INSTRUCTION BULLETIN

No. 340644
Machine: 5400, 5700,
7100, 7200, EZ Rider™
Published: 4-03
Rev. 00

Installation instructions for **kit number 377505**

This kit contains the parts needed to install/replace a new brush drive belt on the models 5400, 5700, 7100, 7200, EZ Rider™ and EZ Rider HP™ scrubbers.

CYLINDRICAL BRUSH DRIVE BELTS

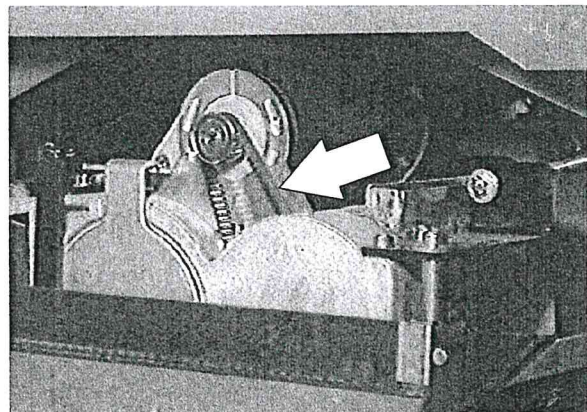
SPECIAL TOOLS / CONSIDERATIONS: Copy the **NEW** polychain belt tension information in customers old machine manuals. Clean or replace all pulleys that appear corroded. Replace seals that appear worn or damaged.

The two brush drive belts are located on the cylindrical brush scrub head. The belts drive the cylindrical brushes. Proper **new** POLYCHAIN belt tension is a 3 mm (0.1 in) deflection from a force of 1.37 - 1.48 kg (3.01 - 3.26 lb) at the belt midpoint.

When re-using an **old** POLYCHAIN belt, measure and record the belt tension before removal, so that the belt can be reinstalled at the same tension.

If the old belt tension was not recorded, the recommended force per old POLYCHAIN belts is 1.03 - 1.14 kg (2.28 - 2.52 lb) with a deflection of 0.10 inch.
